Re: Summit Carriage Homes – Drainage Addendum #2 to SWPPP
Job # SY-1798

- 8.54 acre parcel along Summit Park Road, New Hempstead, NY
- Section 42.10, Block 1, Lot #45
- Reference: SWPPP prepared by LJA (Leonard Jackson Associates) last revised 8-14-14 and subsequently updated with Addendum #1 prepared by LJA dated 7-28-15.

Summit Carriageway
 Homes Sy-1798
 PART PLAN OF
 PROPOSED WORK
 AREA @ 1"=20'
 4/15/20
 Figure 1

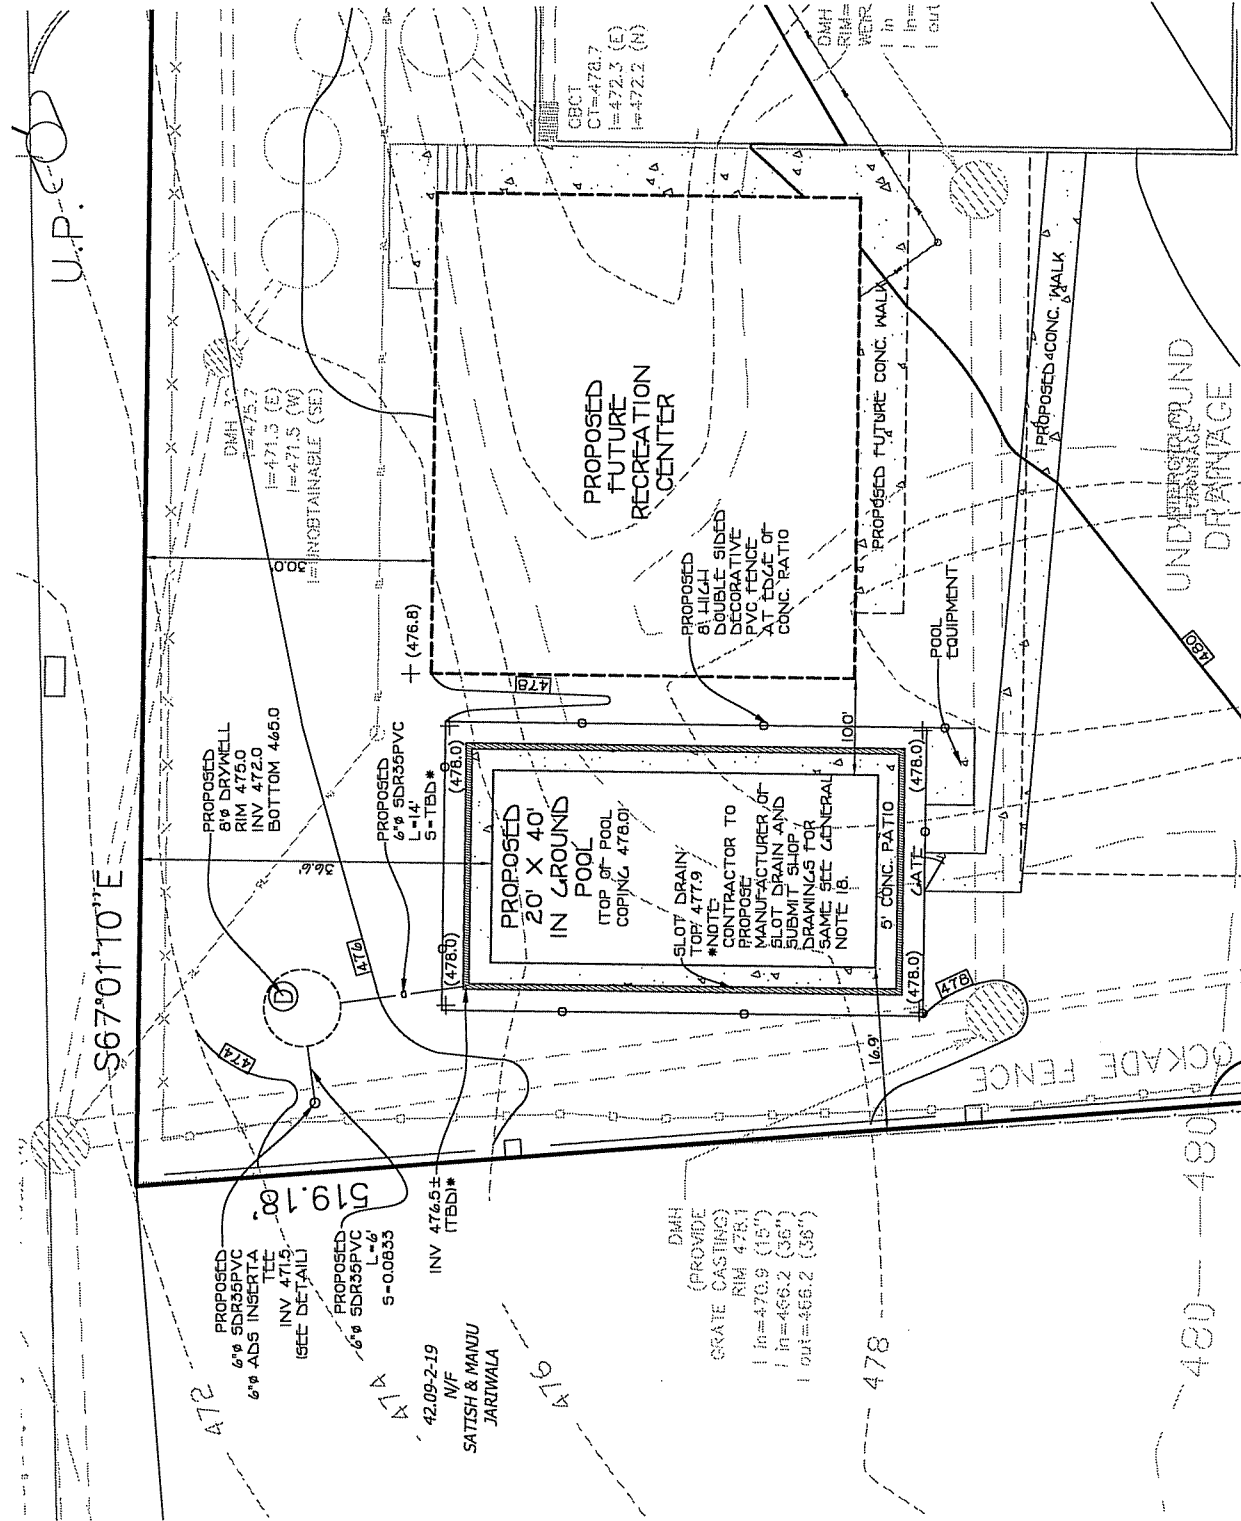
A minor change to the plans is now proposed to add a pool and patio area adjacent to the community center as this amenity has been requested by the homeowners who currently reside at the facility.

Originally LJA determined that (4) 8-foot diameter, 7-foot deep drywells were necessary in this area to accommodate the proposed impervious area. The proposed increase of the pool and patio areas will require (1) additional 8-foot diameter, 7-foot deep drywell (see detail attached) to be added onsite to handle the new pool and patio areas proposed for this submission.

It is proposed to provide slot drains around the perimeter of the pool to catch pool and patio runoff and this will be conveyed directly to one 8-foot diameter, 7-foot deep drywell. The overflow from this drywell will be connected directly to the existing onsite 36-inch stormline draining Kim Lane at the Northwesterly corner of the site.
